Access Compliance Report Public Rights-of-Way (Curb Ramps)

Main Street: MYSTIC_LN Cross Street: HARVEST_LN Location: SW

ADA ID: RPRK210927152448 Ramp Type: Type 6 - Directional 1 Initial Pass/Fail: Pass Overall Compliance: No Severity Score: 10

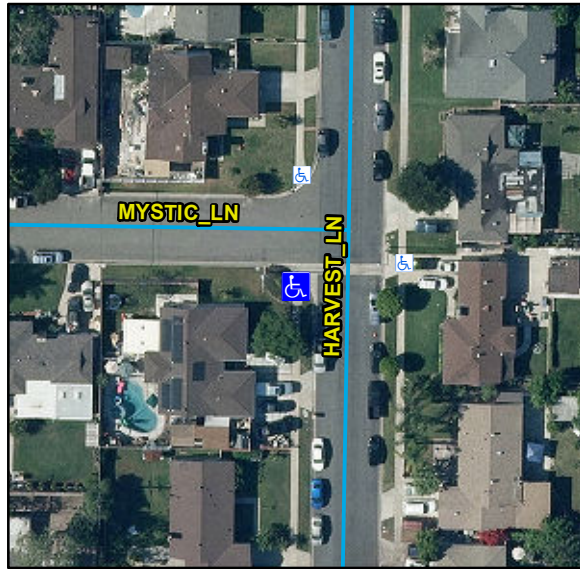
R304.2.2, R204.3, R304.2.2-Perp, R304.3.2-Para,
R304.5.2, R305, STD 1115

Compliance	Description	Data	Compliance	Description	Data
N/A	Ramp Length (in)	95	N/A	Flare Type LT	
Yes	Ramp Width (in)	80			Sloped
Yes	Ramp Run Slope (%)	5	N/A	Flare Slope LT (%)	3
Yes	Ramp Cross Slope (%)	0.7	N/A	Flare Traversable LT	No
No	Grade Break	No	Yes	Flare Type RT	
N/A	Grade Break Slope (%)	N/A			Curbed2
N/A	Grade Break Cross Slope (%)	N/A	N/A	Flare Slope RT (%)	N/A
	Addl Para Ramp Left?	No	N/A	Flare Traversable RT	N/A
	Addl Para Ramp Right?	No	No	DWS Provided	No
N/A	Landing Present	Yes	N/A	DWS Contrast	N/A
Yes	Landing Length (in)	48	N/A	DWS Length (in)	N/A
Yes	Landing Width (in)	48	N/A	DWS Full Width	N/A
No	Landing Run Slope (%)	3.2		DWS Offset Type	N/A
Yes	Landing Cross Slope (%)	1.6	N/A	DWS Left Offset (in)	N/A
N/A	Landing Movement Obstructed?	No	N/A	DWS Right Offset (in)	N/A
	Landing Movement Type	N/A			
N/A	Landing Shared	Yes			
N/A	Marked Crosswalk 1	No	N/A	Clear Space	N/A
	Crossing 1 Direction	N	N/A	Clear Space To Crosswalk (in)	N/A

N/A	Marked Crosswalk 1 Width (in)	N/A			
N/A	Ramp Inside Crosswalk 1	N/A			
	Crossing 1 Slope (%)	6.6			
	Crossing 1 Cross Slope (%)	2.4			
Yes	Gutter Ponding	No	No	Curb Slope	13.2
Yes	Gutter Lip Height (in)	0		Road Run Slope (%)	N/A
Yes	Gutter Run Slope (%)	1.1		Road Cross Slope (%)	N/A
Yes	Gutter Cross Slope (%)	1.2		Parallel Ramp Side	Left
Yes	Overall Surface Condition	Acceptable	No	Perp Joint Present	No
	Cross Gutter Present?	Yes		Spandrel Present?	Yes
	Replace Cross Gutter?	No		Replace Spandrel?	No

Remove & Replace Entire Ramp.
